ZONING MAP AMENDMENT STAFF REPORT SARASOTA MEMORIAL HOSPITAL

May 7, 2019

18-09RZ

REQUEST: Zoning amendment to revise the existing Planned Commercial Development (PCD) district zoning of the subject property to allow for the proposed uses of hospital and related healthcare facilities.

Minimum Parking Space Dimensions

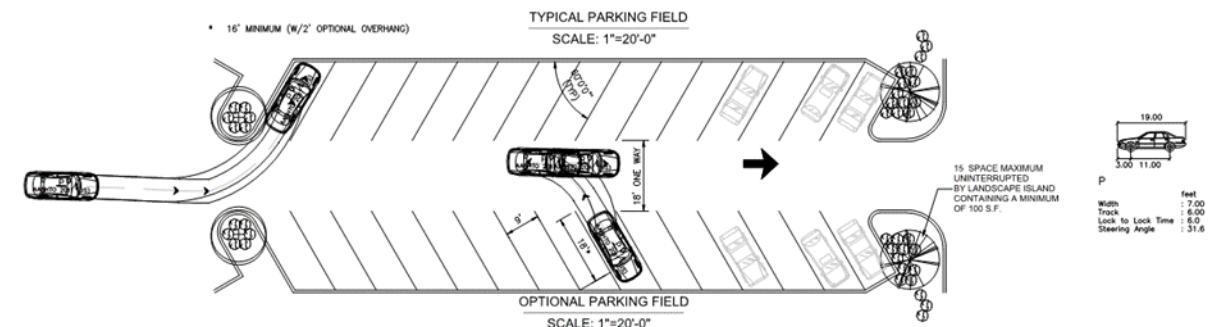
Staff Comment: *The applicant requests to reduce the drive aisle width for one-way traffic from the required 20 feet to 18 feet for an optional parking field design provided on sheet 4 of 4 in the binding master plan. The applicant has provided an example from the City of Sarasota's code to justify their*

Below is a representative exhibit showing the maneuverability of a vehicle utilizing an 18-foot wide drive aisle.
